# US60: Owensboro Bypass Section 2

## Value Engineering & Constructability Study

VE#201101  
Item #02-0287.10  
February 9-10, 2011  
Prepared by Brent A. Sweger  
Quality Assurance Branch  
Division of Highway Design

Final Report: March 1, 2011

*VE#1*

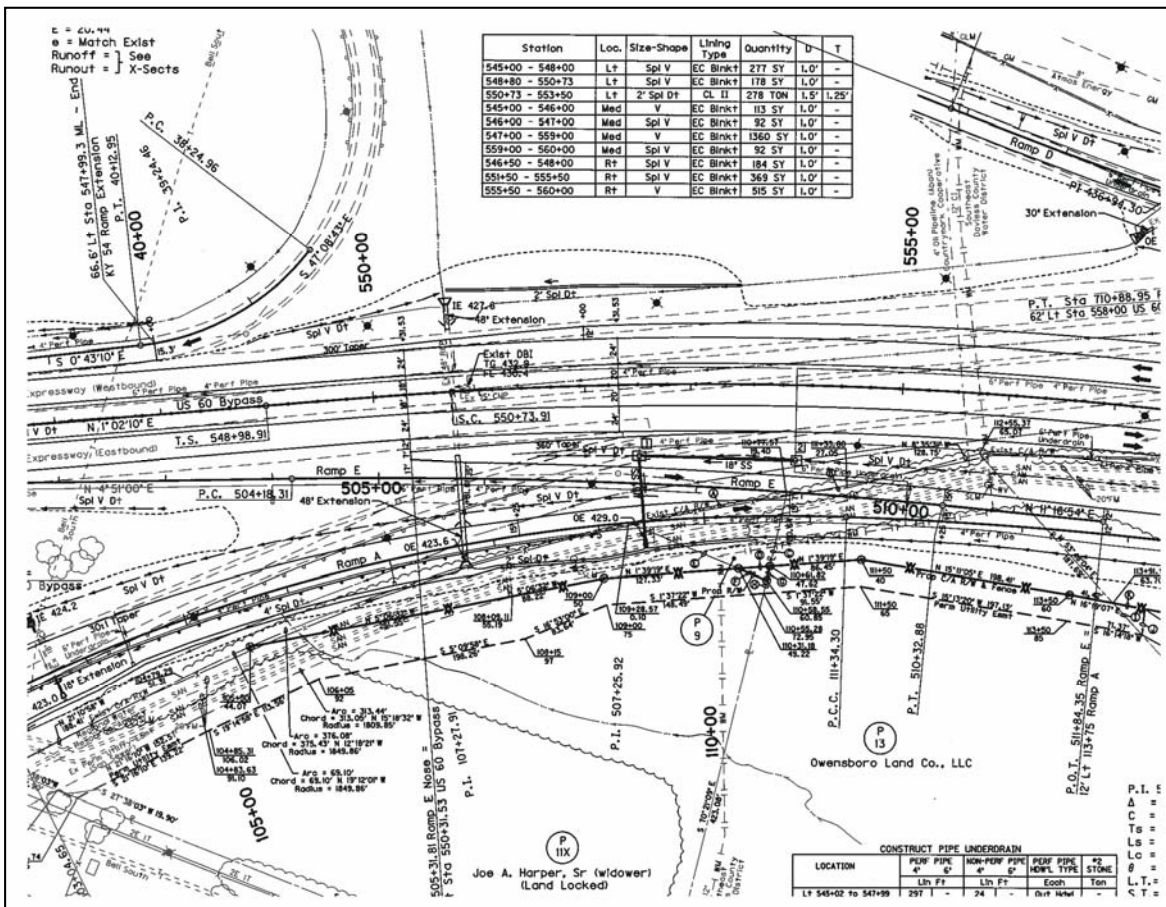
The VE team recommends that the project be amended to build a new eastbound KY54 to westbound US60 entrance ramp to a diamond-style ramp. The cloverleaf ramp would remain in place for westbound KY54 to westbound US60 traffic.

The area served by this interchange has grown significantly over the last several years. Many new businesses have emerged that have caused large traffic growth through the interchange area. Because of this and the current layout, there are turning movement conflicts that cause traffic delays and queues, and raise the potential for crashes at the interchange area. The completion of this recommendation will eliminate the turning conflicts at the ramp and will allow for more usable length for the left-turn lane to Byers Avenue.

The VE team understands that parcel 6 had once contained a building eligible for the National Historic Register. Currently, that building has been removed from the site. The VE team also learned that the property owner of parcel 6 may be in the process of planning a development for this quadrant. It is important for KYTC to address this change by at a minimum purchasing the right-of-way before any development takes place to allow for future construction of the ramp.

VE# 2

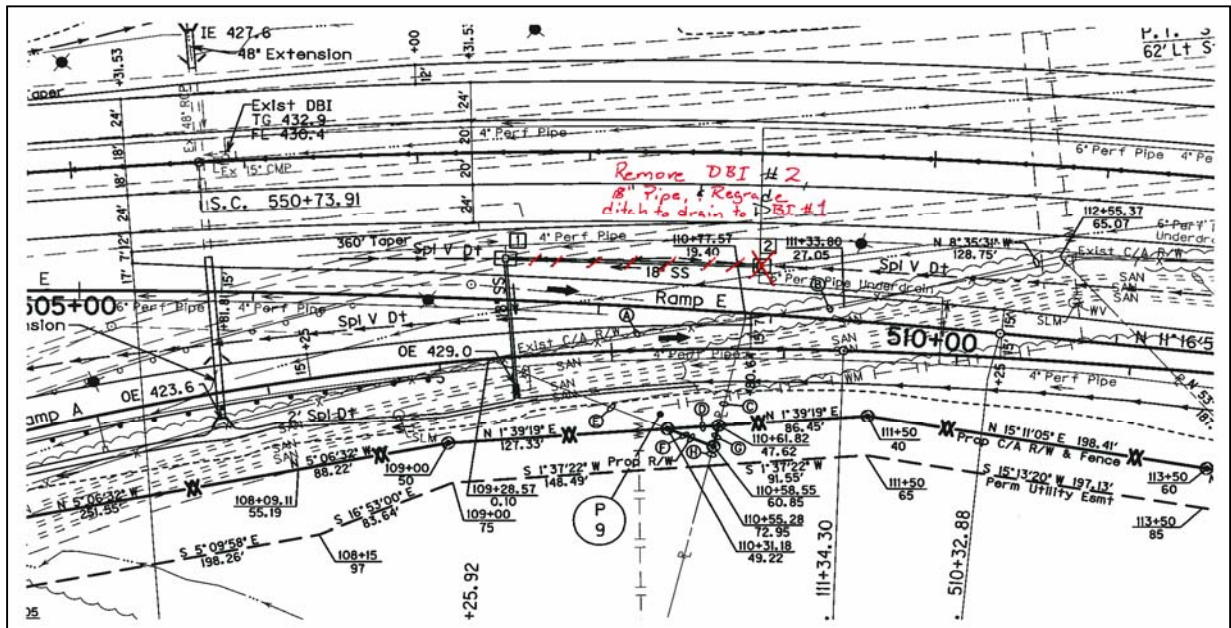
Regrade ditch near station 552+50 to eliminate storm box #2 and associated pipe run.

At approximate station 552+50, the proposed plans show junction boxes labeled 1 and 2 in series within the depressed median. Between the two boxes, there seems to be a break in the ditch, allowing both boxes to receive its own contributing runoff from opposite directions. Junction box 2 seems to be receiving more of the inflow as compared to junction box 1.

By eliminating junction box 2 and the connecting 145' of 18" storm sewer pipe, the break between junction boxes 1 and 2 could be eliminated as well. The contributing inflow to box 2 would then be carried to box 1. The boxes are close enough to each other and the corresponding break may be subtle enough that this can be accomplished.

This change would reduce construction cost as well as reduce possible future maintenance issues for the storm sewer itself. This would also eliminate the swell between the two boxes, which would make the median easier to mow.

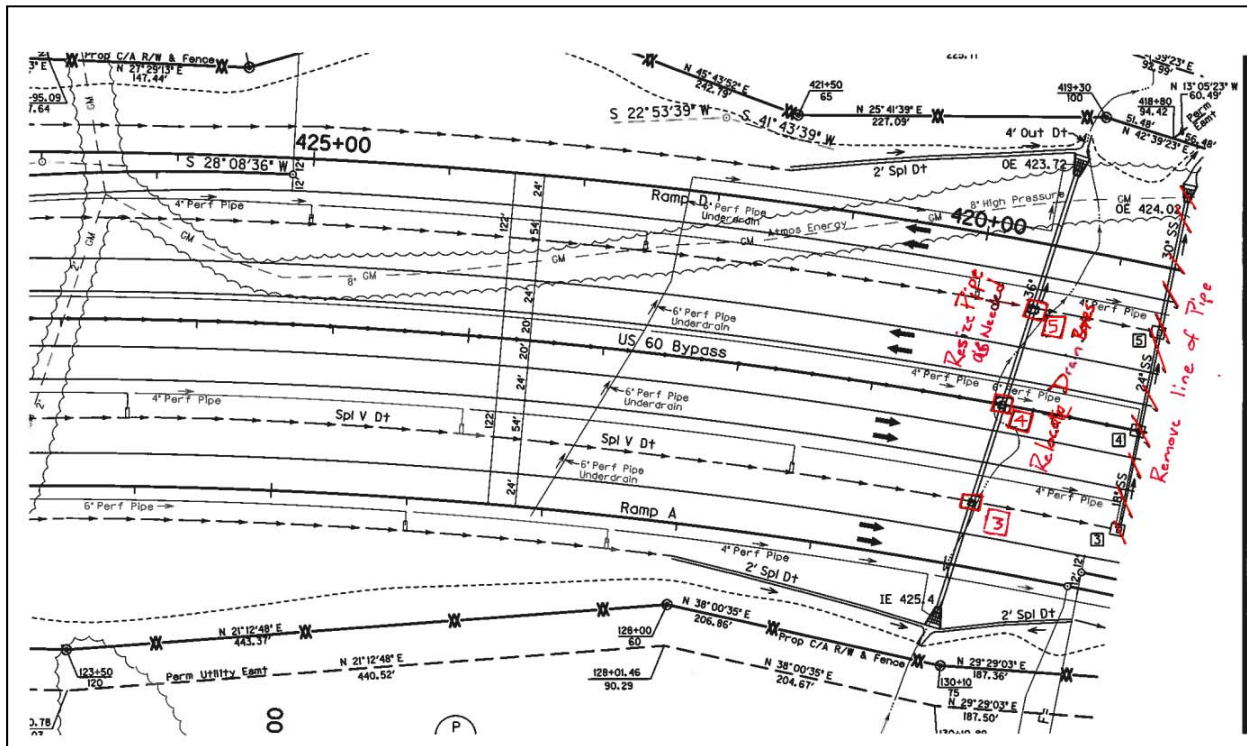
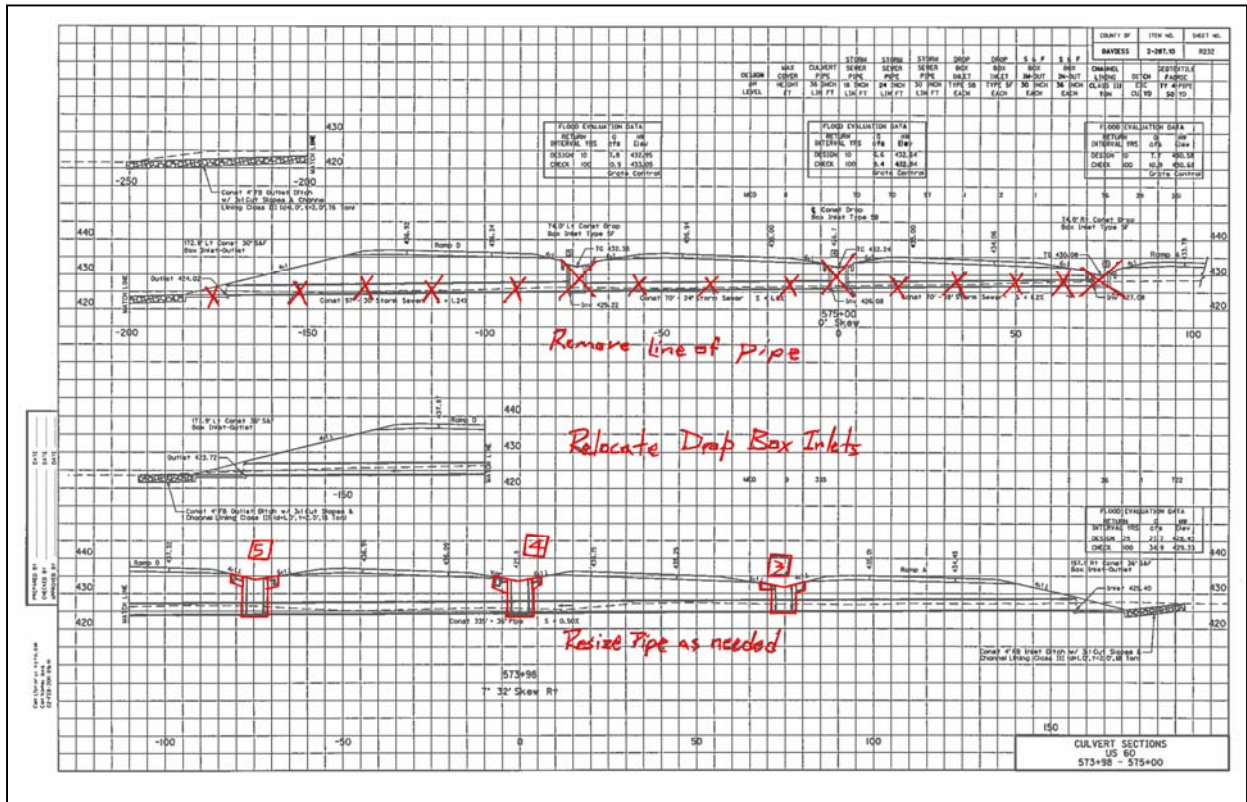
There is a crossing located at station 573+98. Due to the close proximity of the 30" storm sewer system and the proposed 36" crossing just back station of it, it may be possible to combine the two. The drop boxes would still need to be installed to account for contributing ditch flow, however (if capacity allows) the 30" system could be eliminated as well as its corresponding headwall. It should also be noted that the proposed 36" pipe at station 573+98 may need to be upsized to a 42".

This change would reduce future maintenance cost associated with the 30" storm sewer pipe and its resulting headwall. This would also reduce construction cost.

*VE#4*

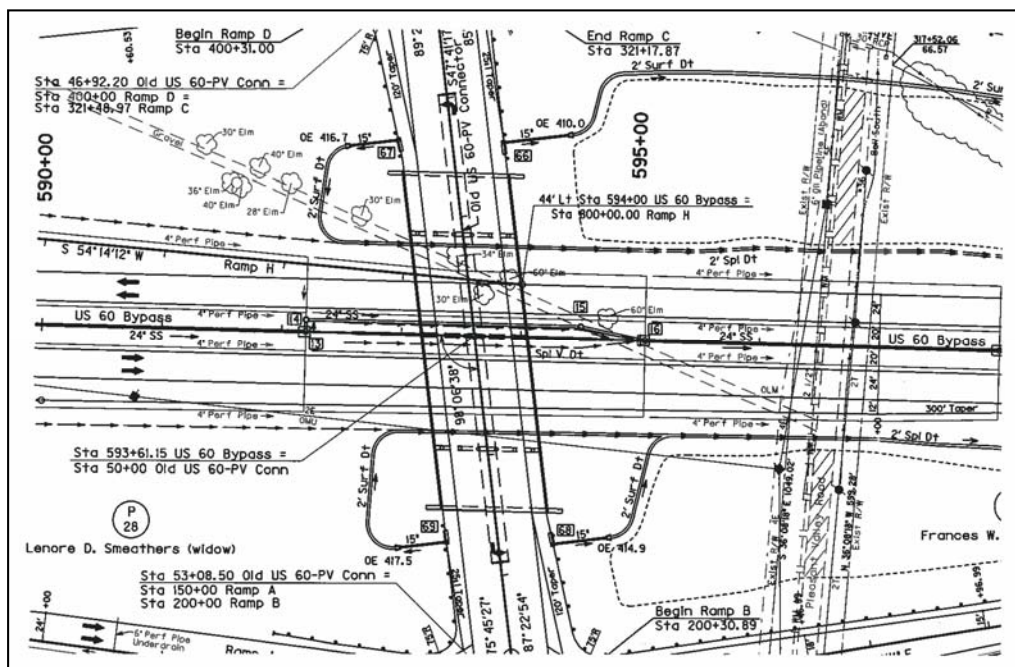
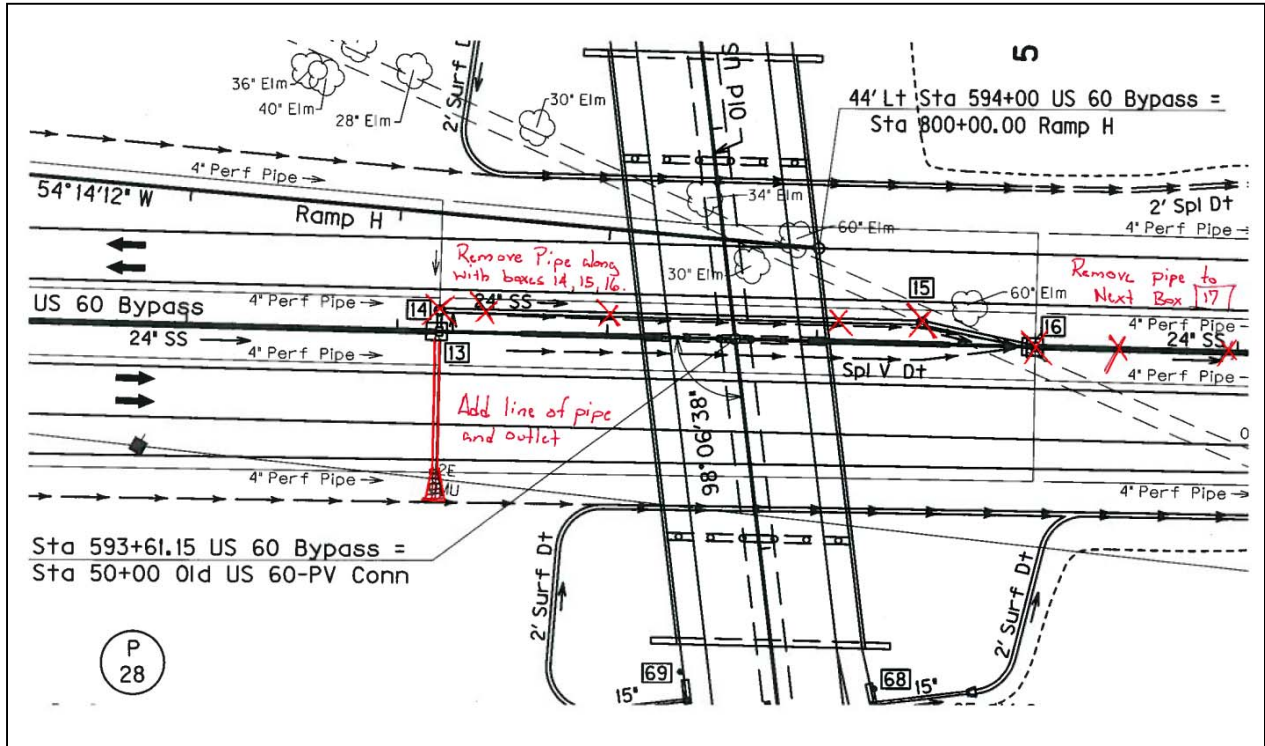
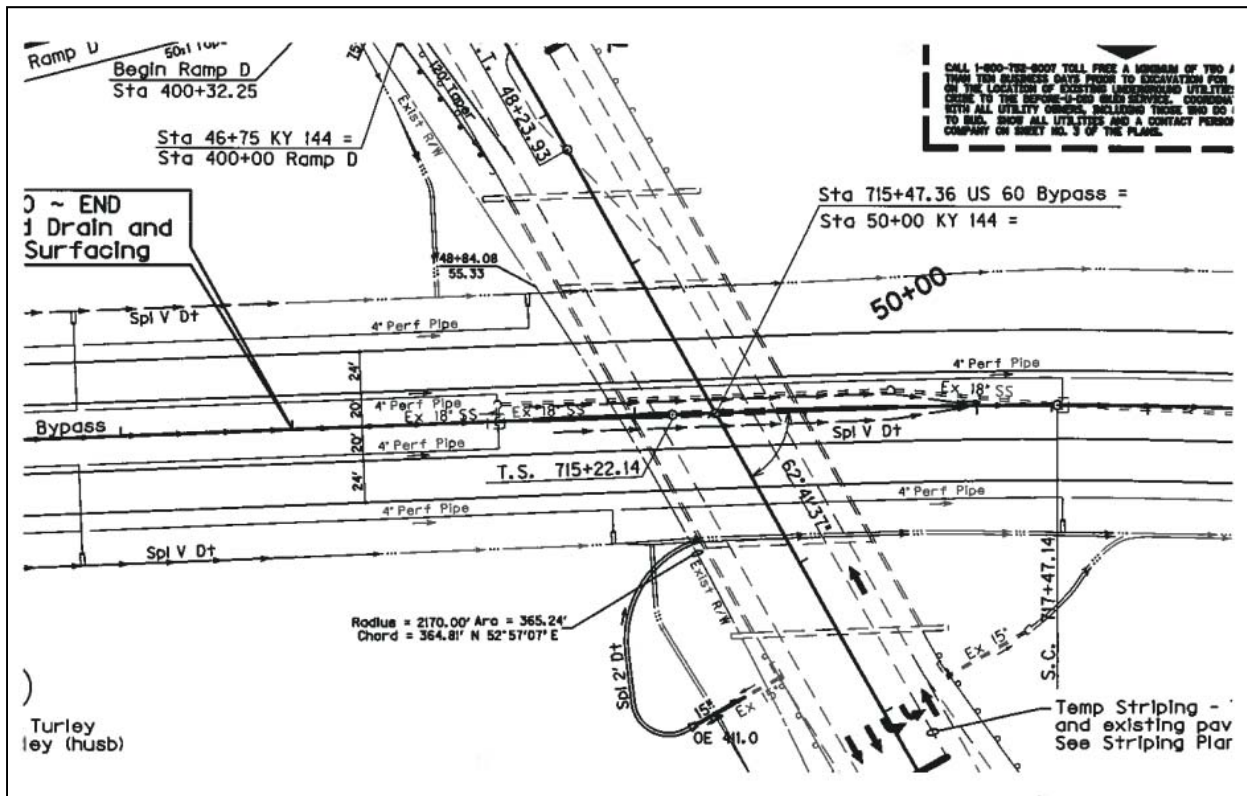
At station 592+20, the proposed storm sewer system that travels along the depressed median is approaching the piers associated with the overpass. The contributing ditch runoff enters junction box 13, then travels around the piers via manholes 14 and 15. It is brought back into the median to junction box 16 and carried to box 17 through a 24" storm sewer pipe. Then flow continues underground along the proposed alignment from there.

The contributing inflow and ditch flow that enters junction box 13, could possibly be diverted the opposite way via a 24" storm sewer pipe to the ditch on the south side of the proposed alignment. This would then travel through a 24" headwall at the proposed ditch. Proposed manholes 14 and 15 could then be eliminated; as well as junction box 16 and all 24" storm sewer pipe in-between. The storm sewer pipe between boxes 16 and 17 could also be eliminated, and the contributing ditch runoff could be picked back up via junction box 17. This may also allow for the reduction of the proposed 24" storm sewer pipe between junction box 17 and 18 to be reduced to an 18" pipe. This design would also necessitate regarding of the receiving ditch in this area.

This change would reduce maintenance cost as well as construction cost. This change would also possibly eliminate constructability issues related to the installation of a storm sewer network around the existing piers for the overpass.

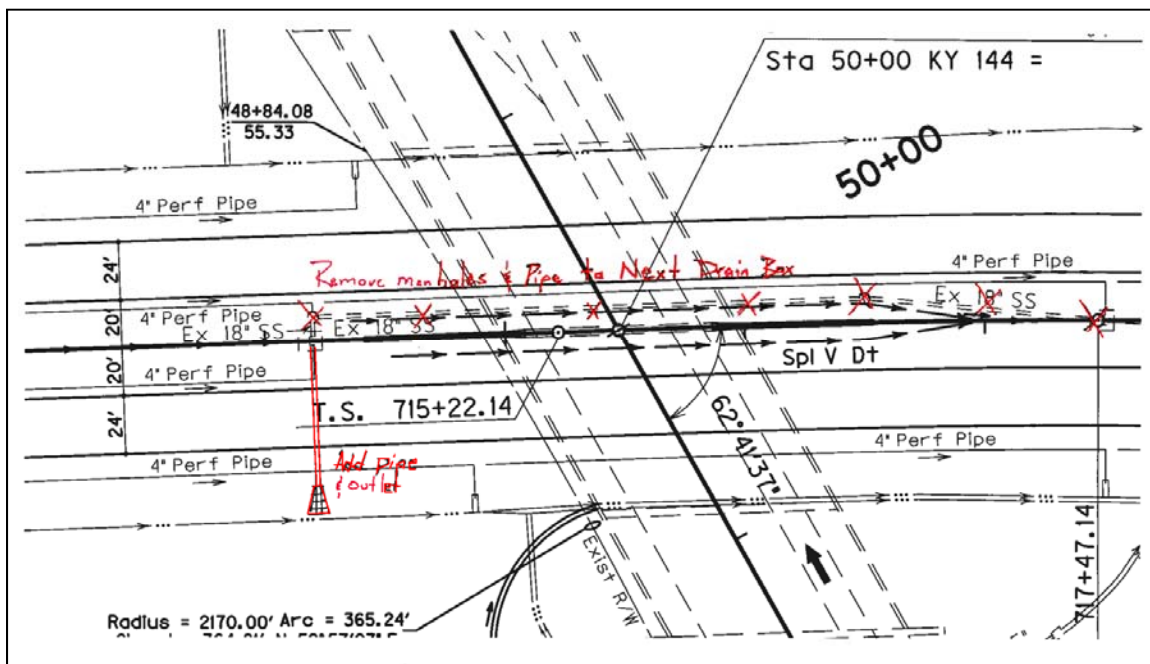
Though this is relative to another phase of construction, the following may be applied depending upon if the storm sewer network has been installed at this point. At station 712+00, the proposed storm sewer system that travels along the depressed median is approaching the piers associated with the overpass. The contributing ditch runoff enters a junction box, then travels around the piers via two manholes. It is brought back into the median to a junction box and carried to a box through an 18" storm sewer pipe. Then flow continues underground along the proposed alignment from there.

The contributing inflow and ditch flow that enters the first junction box could possibly be diverted the opposite way via a 18" storm sewer pipe to the ditch on the south side of the proposed alignment. This would then travel through a 18" headwall at the proposed ditch. The proposed manholes could then be eliminated; as well as a junction box 16 and all 18" storm sewer pipe in-between. Additional 18" storm sewer pipe could also be eliminated, and the contributing ditch runoff could be picked back up via the downstream junction box. This may also necessitate regarding of the receiving ditch in this area.

This change would reduce maintenance cost as well as construction cost. This change would also possibly eliminate constructability issues related to the installation of a storm sewer network around the existing piers for the overpass.
